Mechanical Board

Emergency meeting agenda

Subject: Complaint: Appeal of Mechanical Permit MEC25-00468 under ORS 455.070(3)

Discussion #5 - That the exhaust termination meets distances to operable opening.

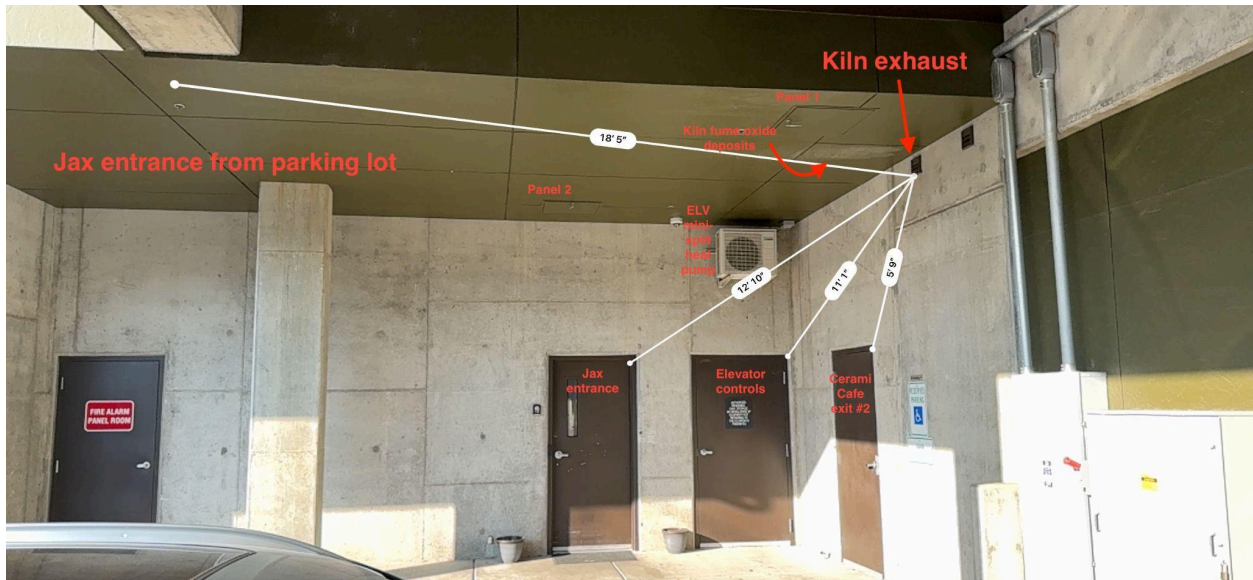
OMSC 501.3.1.2 requires exhaust terminations for ducts and outlets classified under 501.3.1.1 and 501.3.1.2 to be separated from operable openings by at least 10ft. The exhaust termination is situated 5.5ft. from the applicant's second entrance. This rear entrance to the applicant's commercial space is an operable opening to the building and is counted as a working exit to determine occupancy.²⁰

Contrary to the building official's assertion that ambient air mitigates any pollutants being exhausted at this location, the covered parking structure abuts the leeward side of this L-plan building, creating a stagnation zone where ambient air, instead of being dispersed, often settles. The kiln exhaust termination is nestled exactly at this location.

Ambient air mitigation

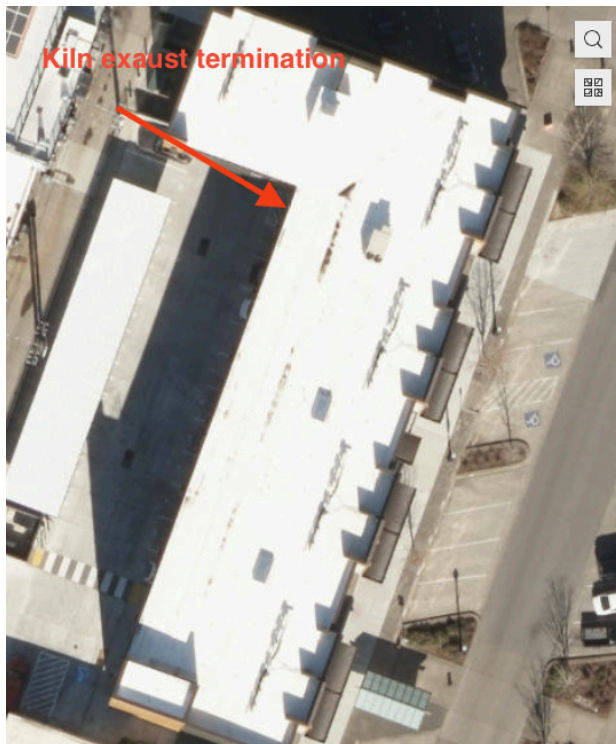
Exhaust terminations for exhaust venting *into* parking garages still deserve assessment and a plain reading of the building code does not absolve us from reasonably characterizing this exhaust. Even if it is asserted that it is substantially similar to car exhaust in its hazard profile, there are good examples of criteria that could be used to assess this exhaust. Consider the following example: the building's owner, Little Blitzen River, LLC, maintains an insurance policy on this building that makes very specific claims on the parking structure in question. Within the parking structure, it distinguishes even between different *locations* of car exhaust, relative to vehicle orientation. While head-in parking orientation is allowed, back-in parking is expressly forbidden due to the likelihood – given the partially covered carport area abutting the building –

CERAMICAFE - FLOOR PLAN LAYOUT

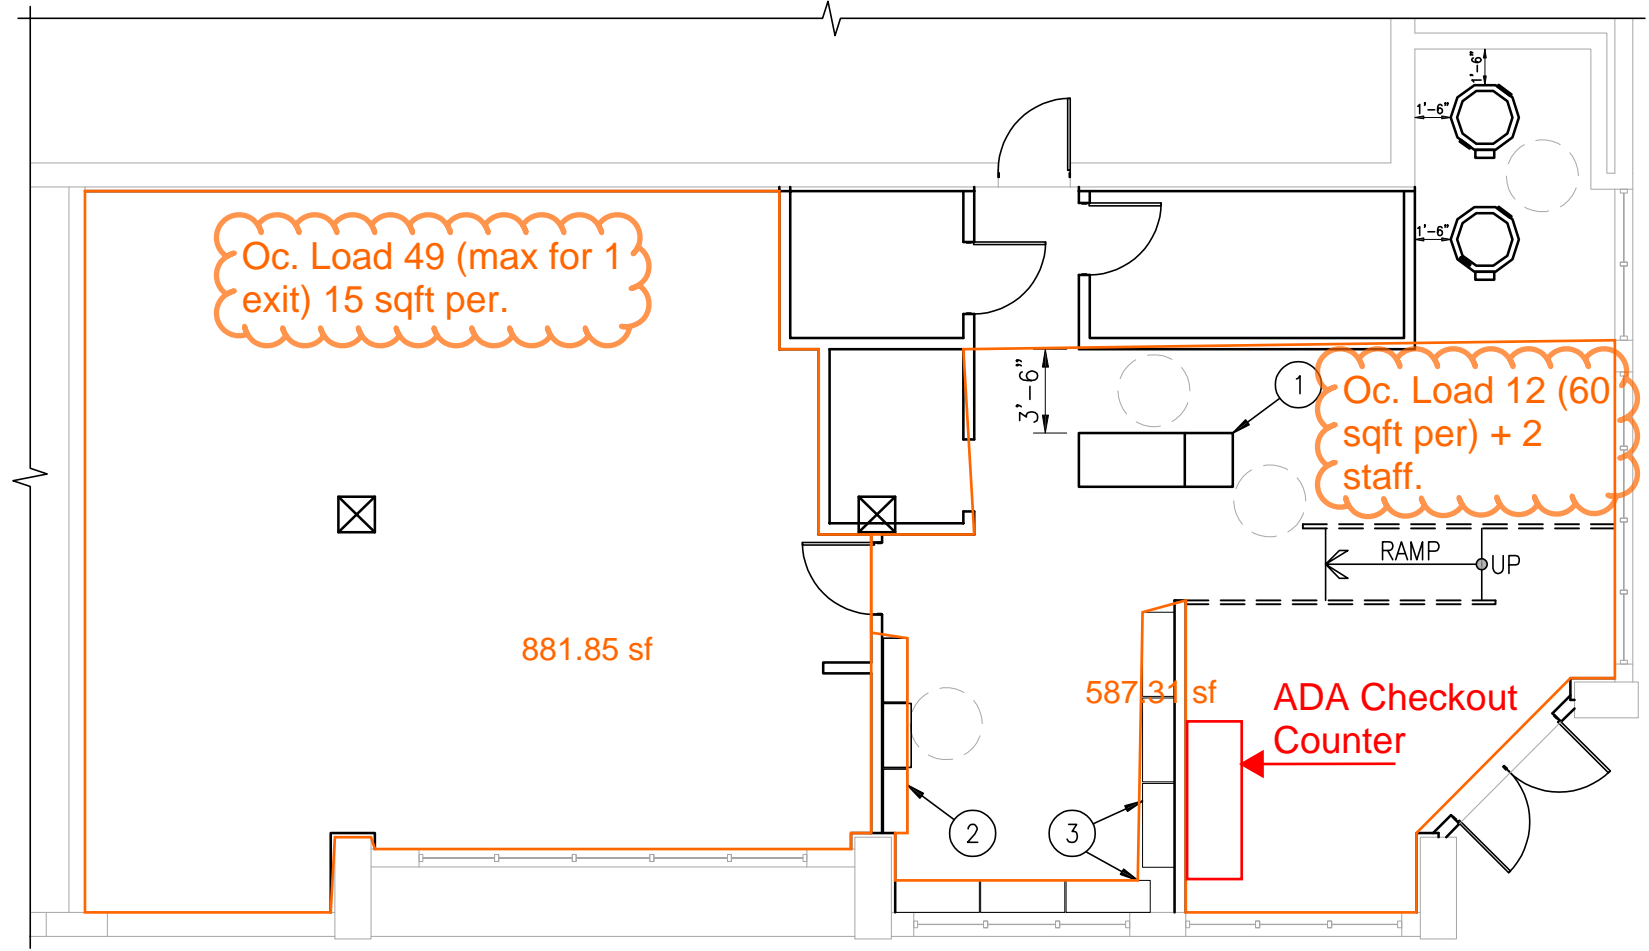
- 1) **ADA Counter Length** – Per ICC A117.1-2017 Section 904.3.2 a portion of the public use side of the counter surface 36 inches minimum in length and 26 inches minimum to 36 inches maximum in height shall be provided. Please update plans to indicate that the ADA portion of the counter will be 36 inches minimum in length. As an alternative the ADA portion of the counter could be 30 inches in length if set up for forward approach which requires knee and toe clearance. ICC A117.1-2017 904.3.3.

- 2) Height of Shelving – Racking and shelving over 5 feet 9 inches in height require an engineered attachment. Please provide an engineered solution for attaching the shelving. OSSC 105.2, 1604.8.
- 3) Electrical Permit Required – An Electrical permit is required for the two 208v circuits that have been installed to power the kilns. No Minor Label was visible on the panel. OESC 90.4.

- 1) Location of Exhaust Outlets – The termination point of exhaust outlets and ducts discharging to the outdoors shall be located with the following minimum distances for other (non-environmental air) product-conveying outlets: 10 feet from property lines; 3 feet from exterior walls and roofs; 10 feet from operable openings into buildings; 10 feet above adjoining grade. OMSC 501.3.1 (2). Please add to the scope of the Mechanical permit to indicate that these requirements will be met. Currently it does not appear that the exhaust outlet meets the requirement to be 10 feet from operable openings into the building.
- 2) Modification of Existing Dryer Vent – It appears that the existing dryer vent input has been relocated to the opposite side of the wall to pick up the kiln exhaust. Please add modifying the dryer vent to the scope of the Mechanical permit. OMSC 106.1
